SUBJECT: PALO VERDE NUCLEAR GENERATING STATION, UNIT 1 - REVIEW OF
STEAM GENERATOR TUBE INSPECTION SUMMARY REPORT
(TAC NO. MC7368)

REVIEW OF THE 2002 AND 2004 STEAM GENERATOR TUBE INSPECTION REPORTS

PALO VERDE NUCLEAR GENERATING STATION, UNIT 1

**Arizona Public Service (APS)
Response to the Staff's Request for Additional Information**

SG - 11 ARC REGION WITH AXIAL INDICATIONS

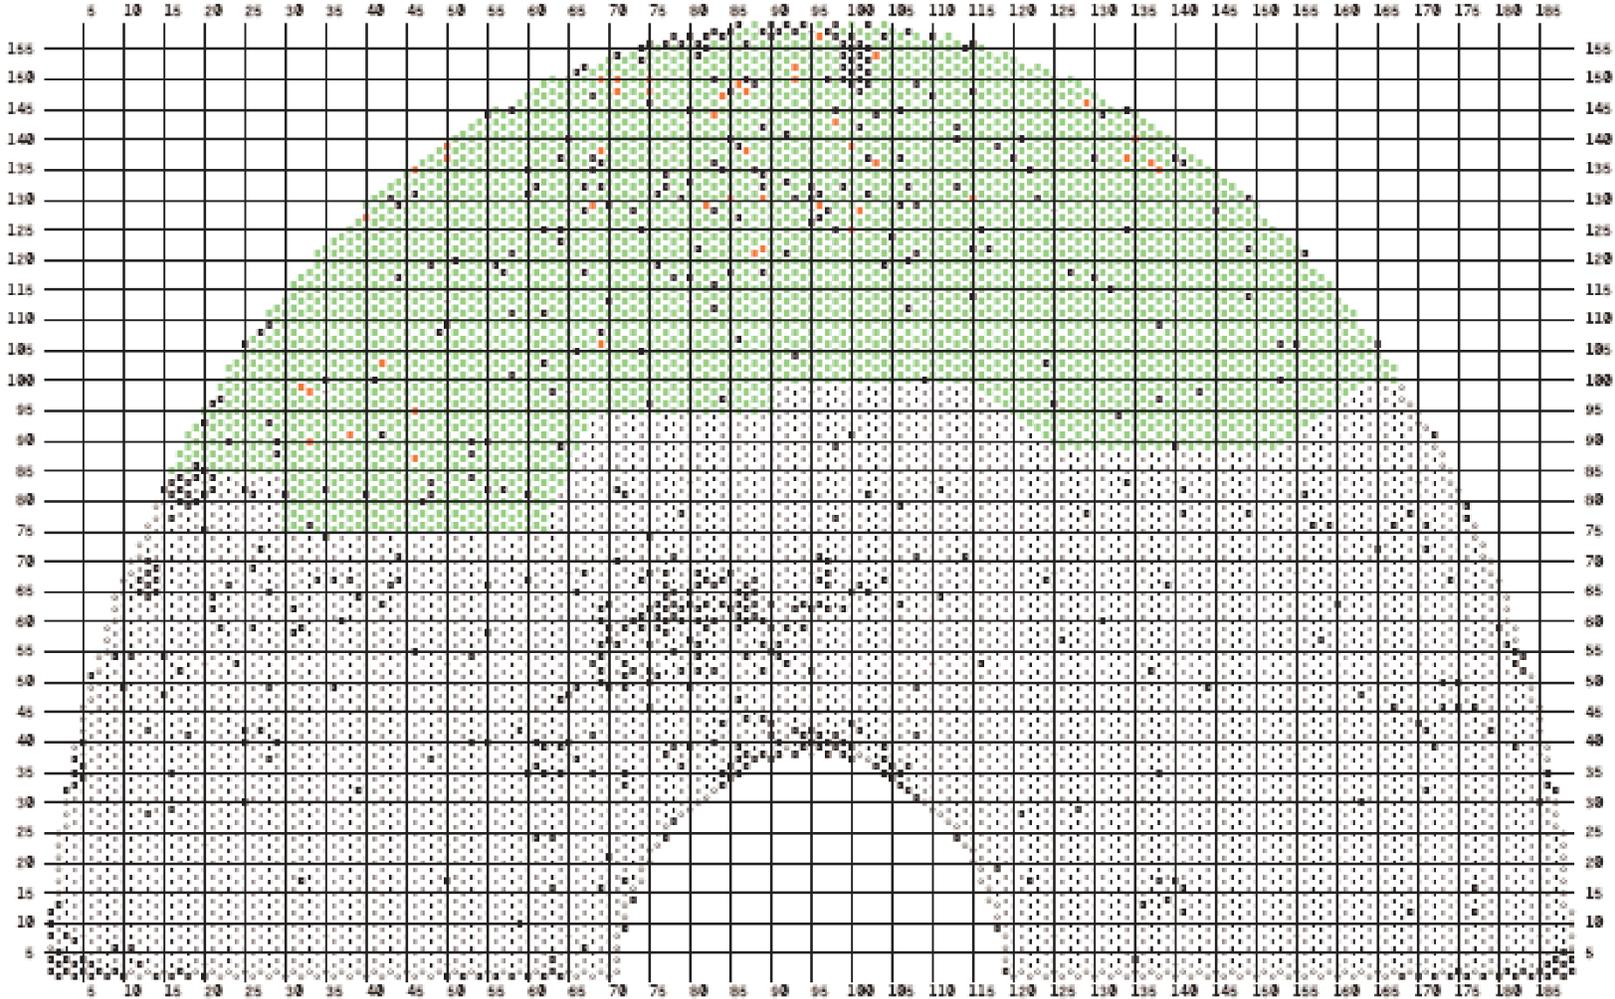
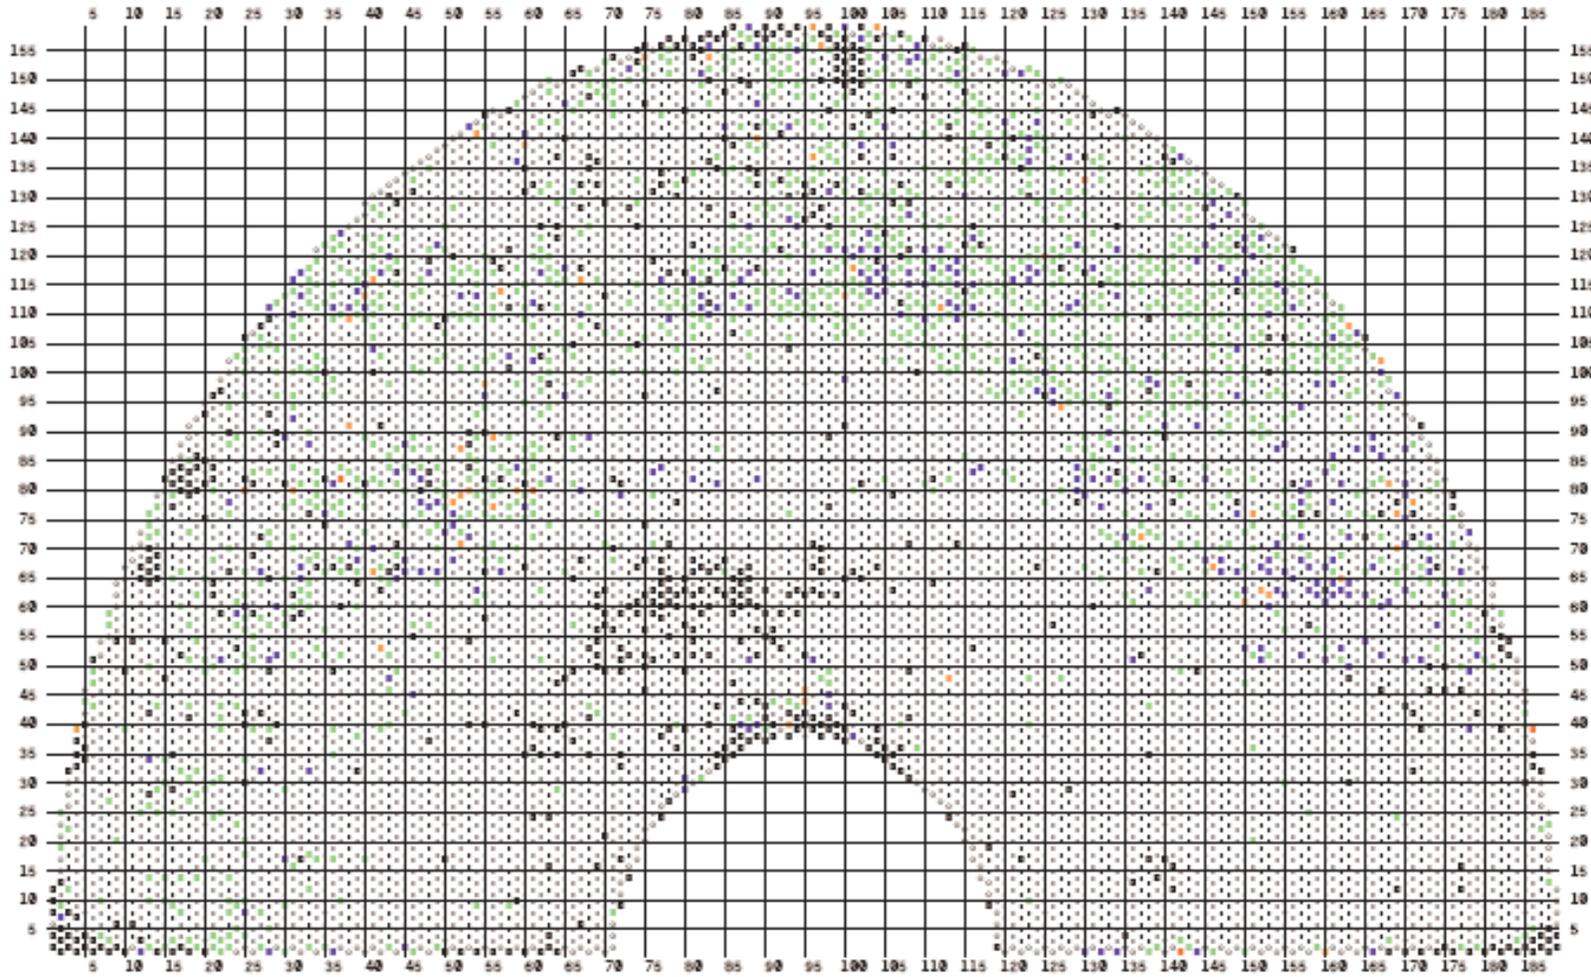
Please clarify the scope of your rotating probe inspections of wear scars during your Unit 1 2004 (U1R11) inspections. The staff notes that your response to Generic Letter 2004-01 indicates that you perform rotating probe inspections of all previous wear calls and all new bobbin indications. However, Table 1 of your April 18, 2005, letter indicates far fewer rotating probe inspections of previous and current bobbin indications than the number of wear indications reported in Table 2. Is this a result of reporting the number of tubes in Table 1 and the number of indications in Table 2. Could this also be a result of some of the wear scars being examined as part of other examinations (e.g., rotating probe exams in the ARC)?

All bobbin wear indications, both new and previously called, are rotating pancake coil (RPC) examined. A significant number of wear indications are within the Palo Verde ARC location (See attached Tubesheet Maps for discussion purposes). These bobbin indications are, therefore, included in the ARC RPC examinations and not scheduled separately.
